Proposed Revisions to a Standard Plans Index

Index Number: 646-001

Index Title: Aluminum Post and Pedestal Mounted
Pedestrian Detectors and Signals

LAST REVISION 11/01/21	DESCRIPTION:		FY 2023-24 STANDARD PLANS	ALUMINUM POST AND PEDESTAL MOUNTED PEDESTRIAN DETECTORS AND SIGNALS	INDEX	SHEET
					646-001	1 of 1

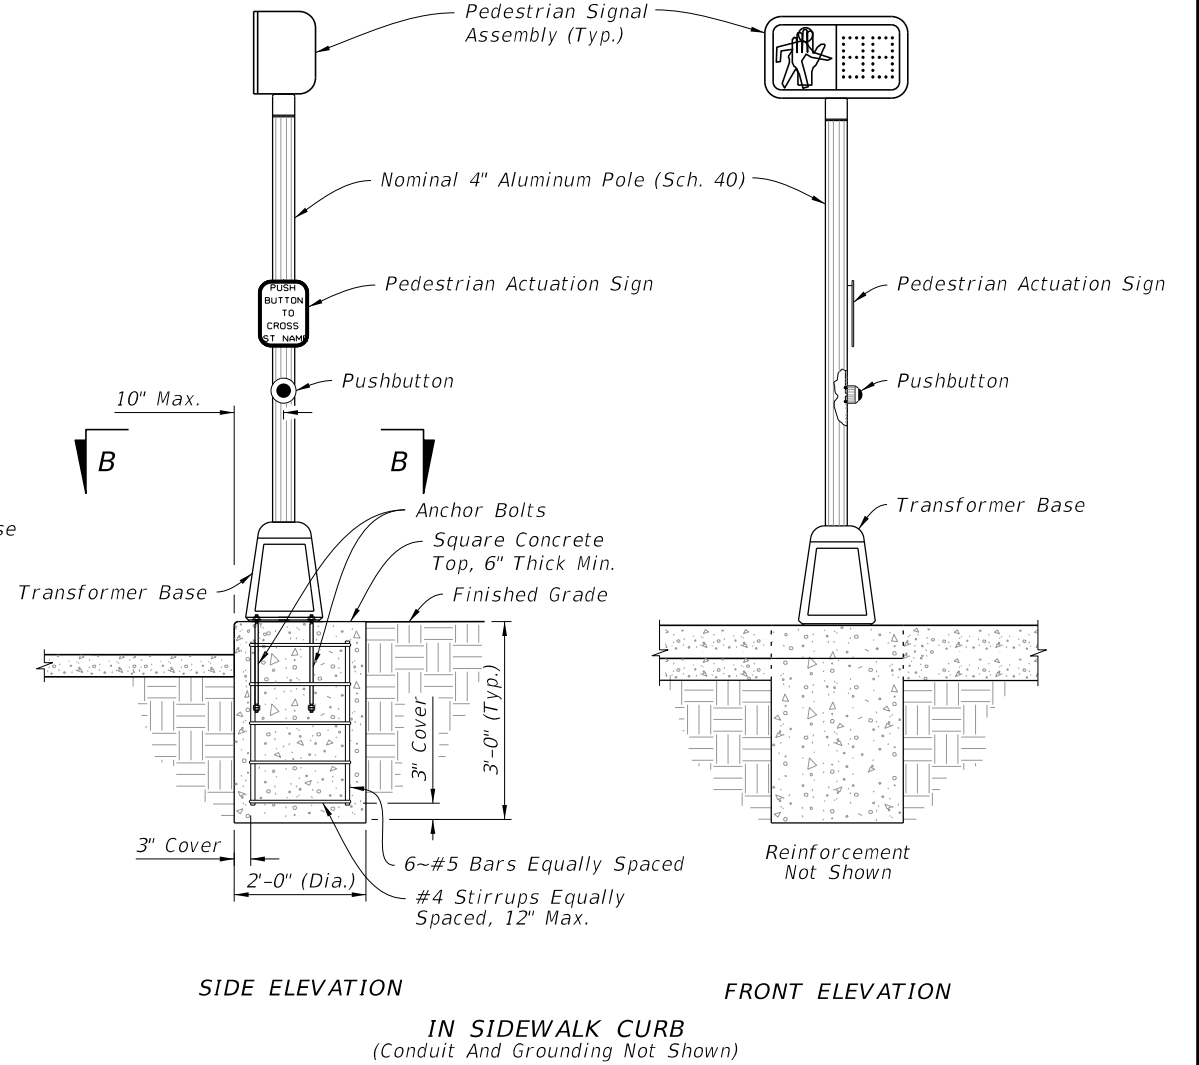
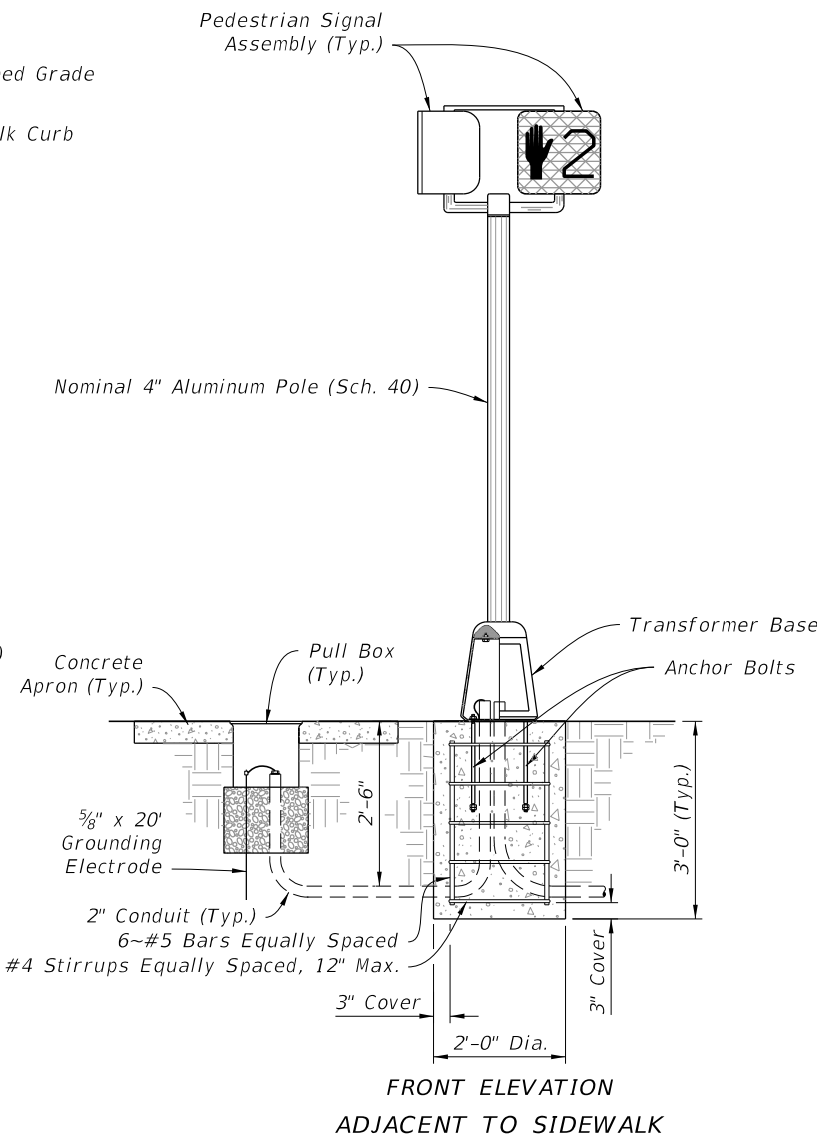
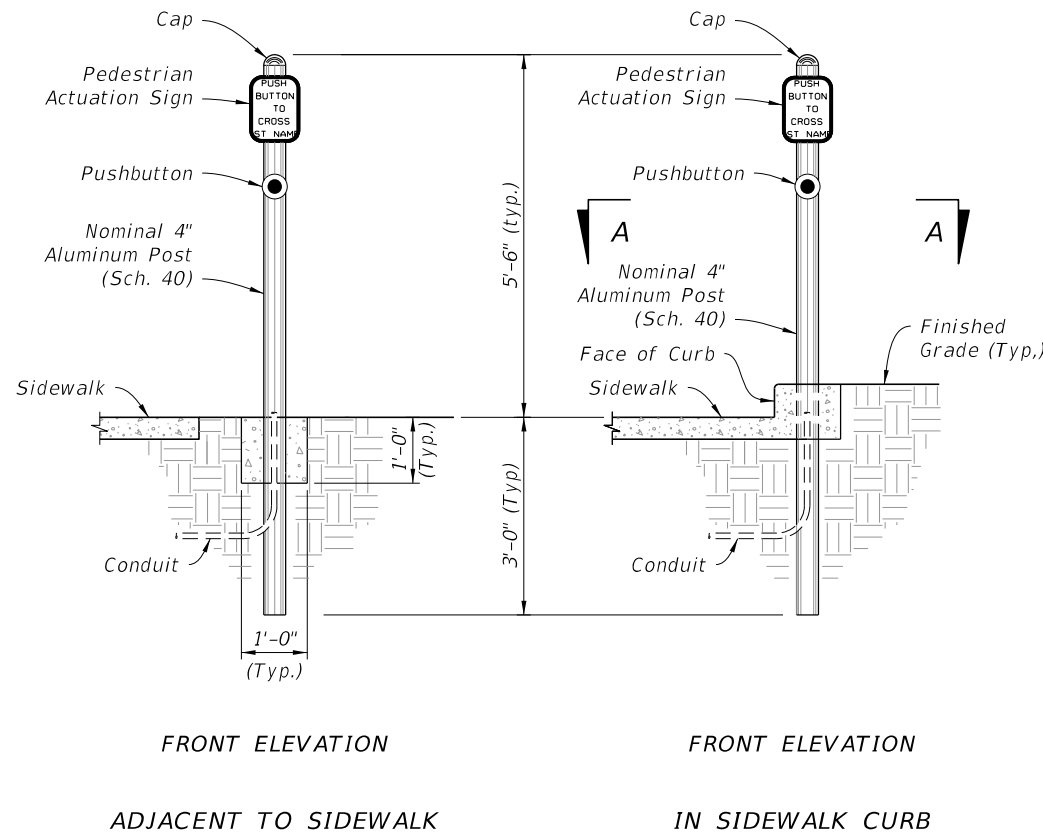
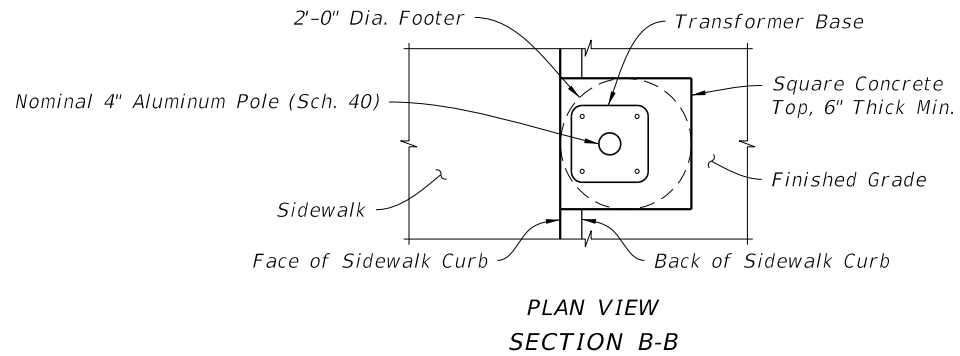
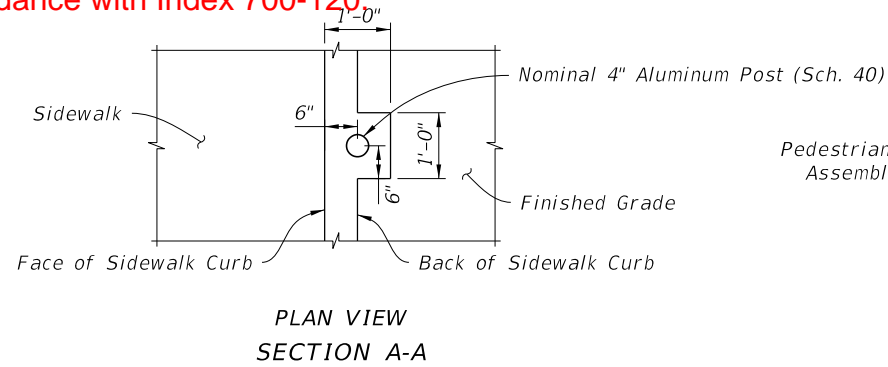
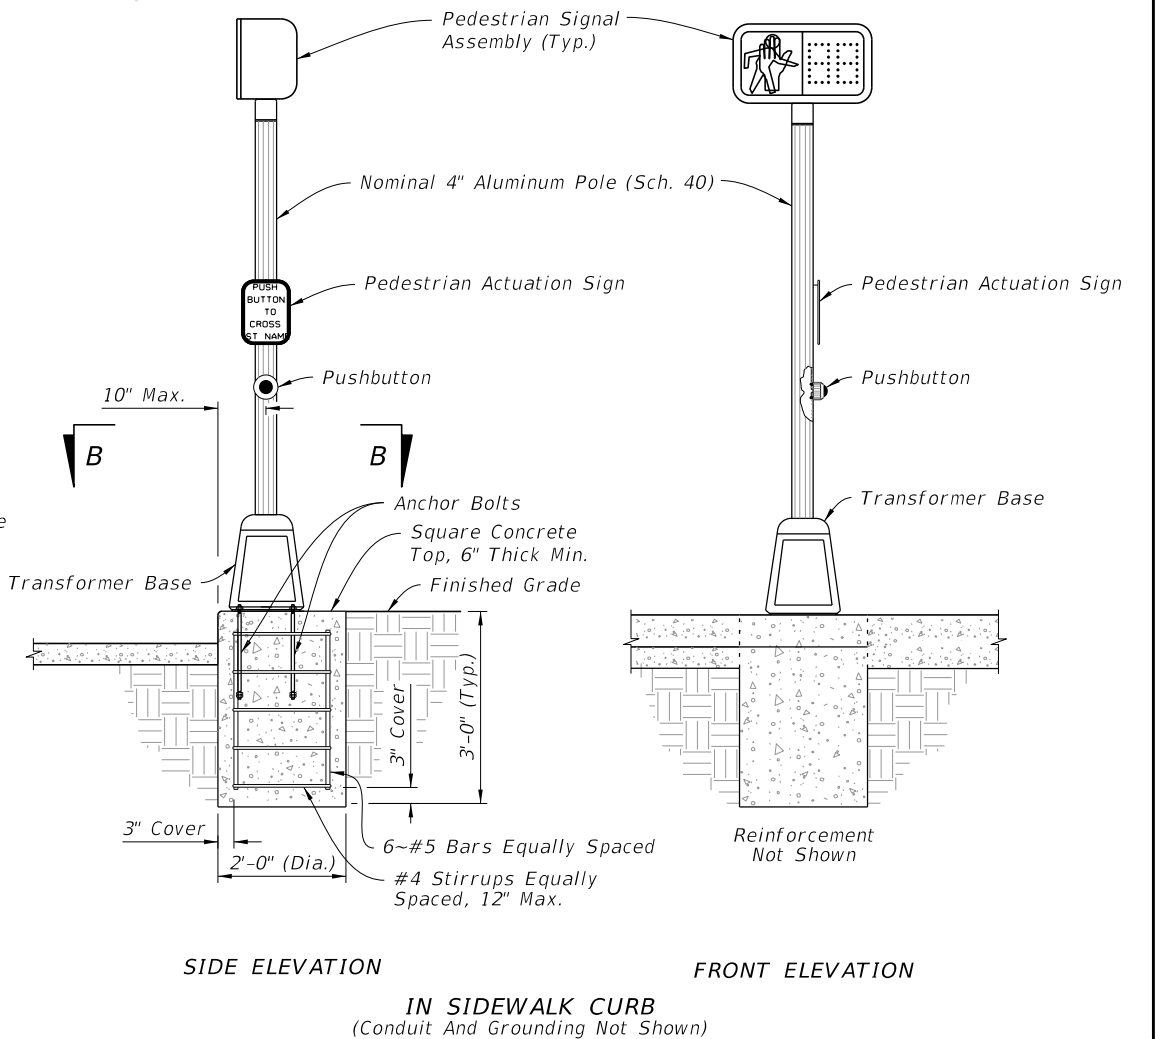
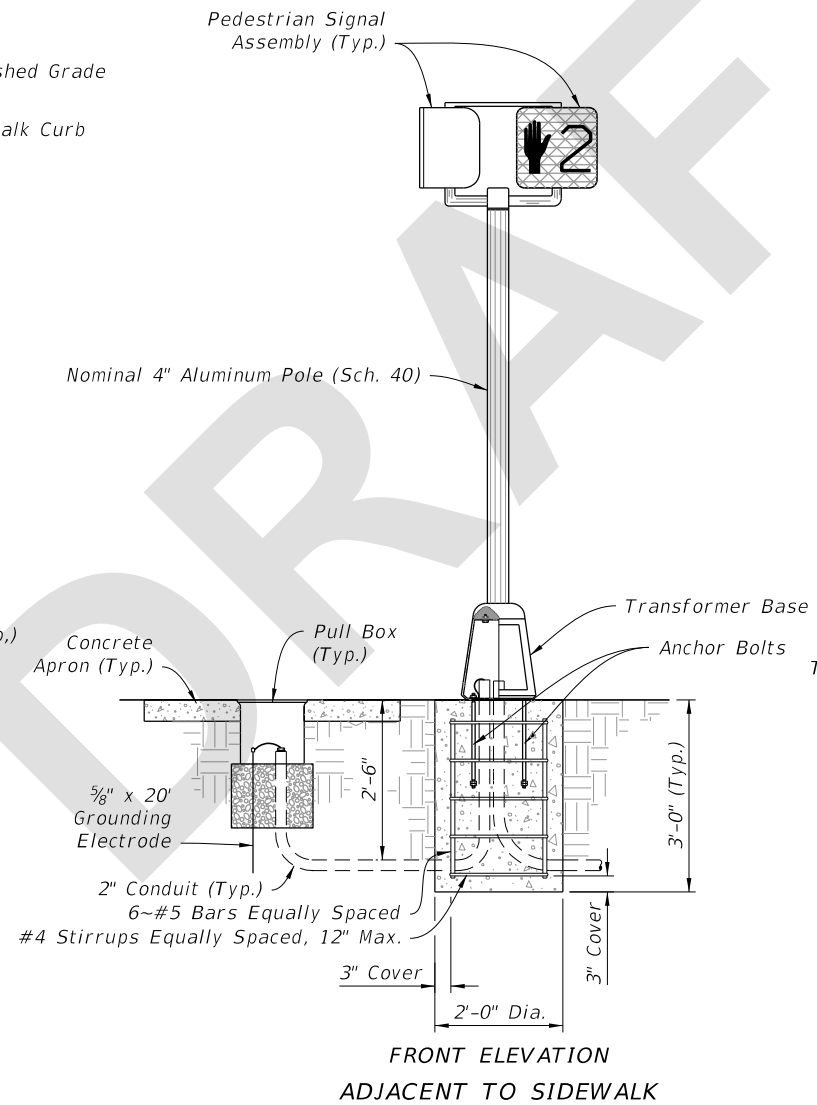
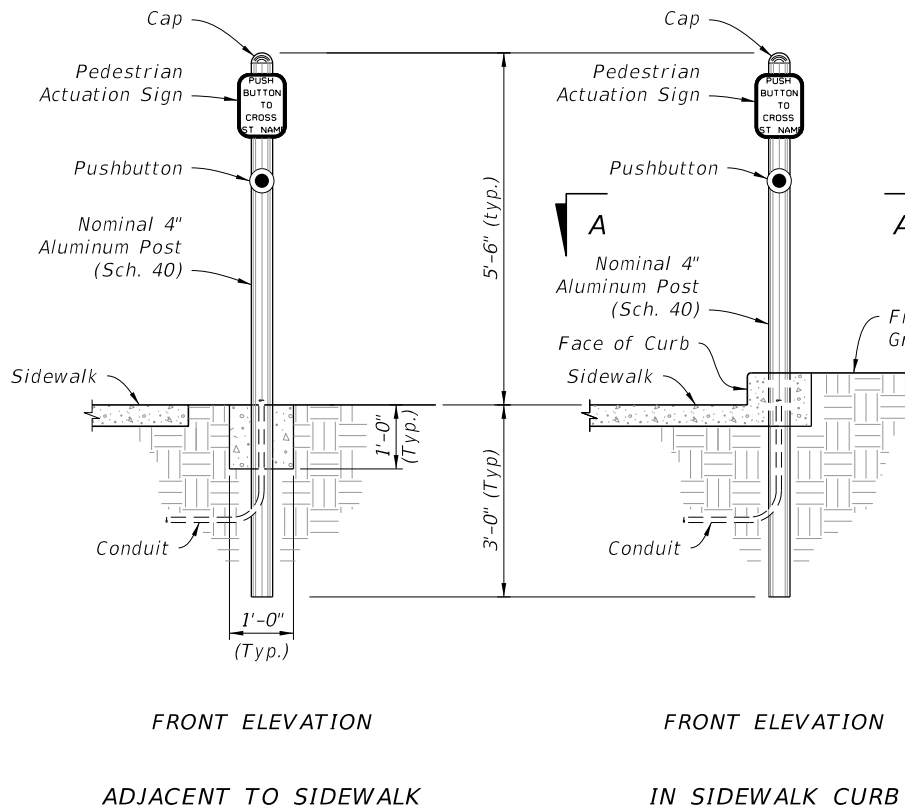
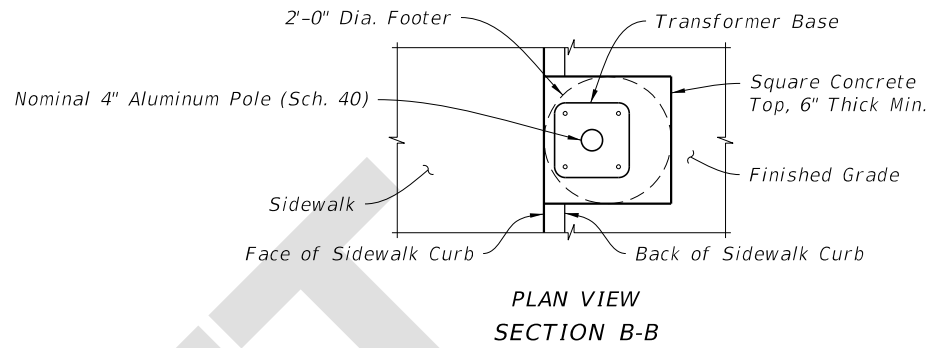
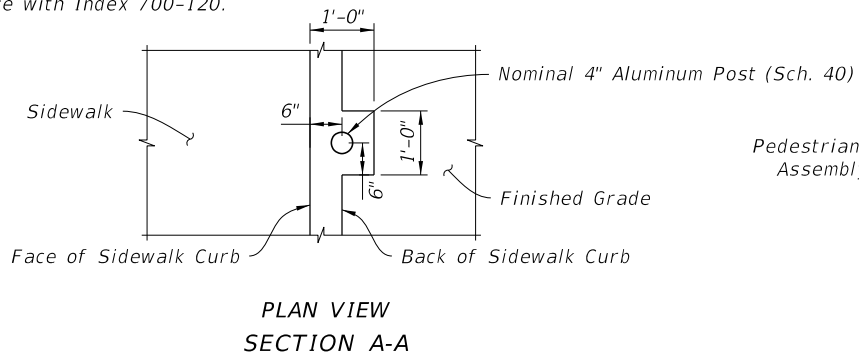
Added Note 6, "In lieu of footing design shown, a Spread Footing may be used in accordance with index 700-120."

Note 6 was added because of new spread footing design in Standard Plans Index 700-120.

6. In lieu of footing design shown, a Spread Footing may be used in accordance with Index 700-120.

1. Work this Index with Specification 646.
2. For Pedestrian Signals see Index 653-001.
3. For Pedestrian Detector Assembly (i.e., Pushbutton and Sign) details see Index 665-001.
4. Footing may be Cast-In-Place (C-I-P) or Precast.
5. As an alternative to the direct buried "Post Mounted" Pedestrian Detector Assembly shown below, the post may be installed on a transformer base. Use a transformer base included on the APL approved as an alternative to a "Post Mounted" assembly,
6. In lieu of footing design shown, a Spread Footing may be used in accordance with Index 700-120.
